Product Change Notification

Bourns Sensors & Controls Product Line Introduces Model 3549 Product Enhancements

SC1282

Current Design *Proposed Design*

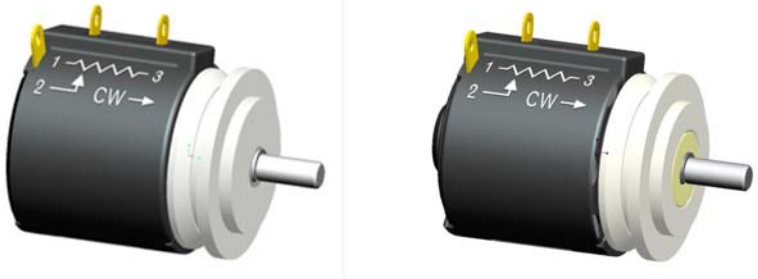
The current process for attaching the servo lid involves a mechanical rivet on the lid that attaches to the potentiometer housing. The new process will entail screwing the servo lid onto the potentiometer bushing. The servo lid will also be glued to the front mounting surface of the potentiometer. This modification is designed to increase reliability.

The appearance of the Model 3549 will be different but the fit and function will not be impacted. Qualification test data is available upon request.
